## **SERVICE BULLETIN NUMBER 121**

TITLE Cooling System.

**APPLICABILITY** Pegasus Quantum and Quik flexwings with liquid cooled

Rotax 912 and 912S engines.

Fig 1 Placard required if Evans NPG is used.

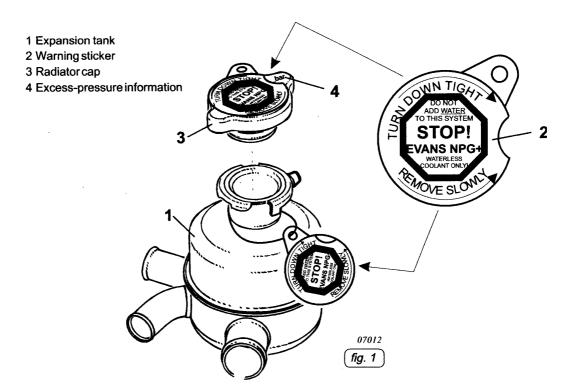
- 5) Alternatively, flush with Evans NPG prep. fluid and refill with 100% Evans Non Aqueous Proplyene Glycol (NPG) coolant. In this case a placard must be applied to the radiator cap "Evans NPG Coolant Add No Water". See fig 1. (Available from Skydrive Ltd, UK Rotax importer)

- 7) If using Evans NPG, fill and drain the system using Evans NPG prep fluid. Apply a placard to the expansion bottle cap "EVANS NPG COOLANT ADD NO WATER". Fill the system with 100% Evans NPG coolant.

Fig 3 Power Plant Assy with Radiator Installation

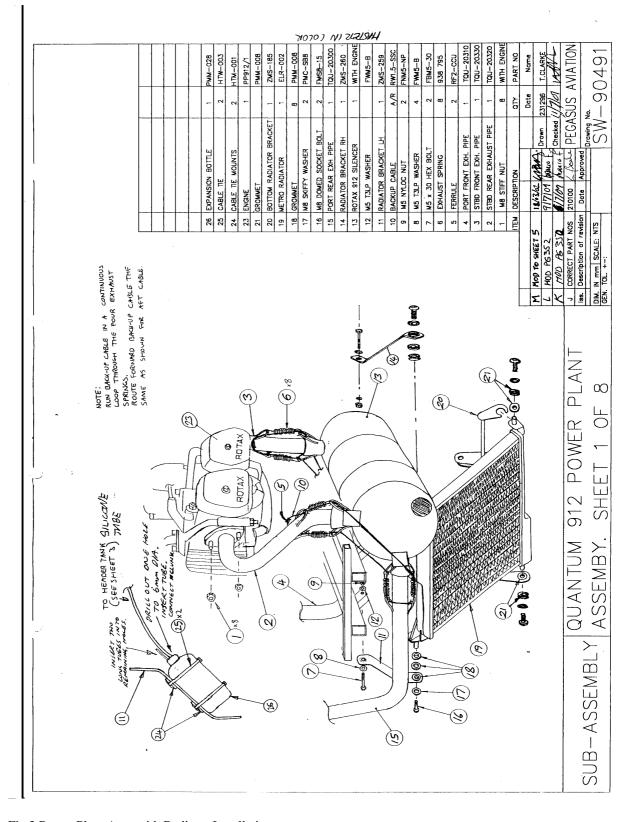
The new all-aluminium radiator part ELR-003, modification M156 part 2, is totally interchangeable with the original plastic header tank ELR-002 radiator and the same mountings are used. The weight and CG change is negligible.

- 1) Follow flushing instructions 1-5 above to drain the coolant.
- 2) Remove the top hose clip and remove the top hose.
- 3) Remove the top and bottom pair of M8 dome allen bolts (See fig 1 below).
- 4) Remove the radiator from it's mounts.
- 5) Inspect the mounting grommets, replace as necessary.
- 6) Re-fit using the M8 allen bolts, apply a drop of Loctite 221 to the threads.
- 7) Re-fit the top and bottom hoses.
- 8) Fill the system according to flushing instructions 6-11 above.
- 9) Record "modification M156 part 2, radiator part ELR-003 fitted" if fitting a new radiator, or "radiator replaced with original type ELR-002" as appropriate. Available from P&M Aviation.
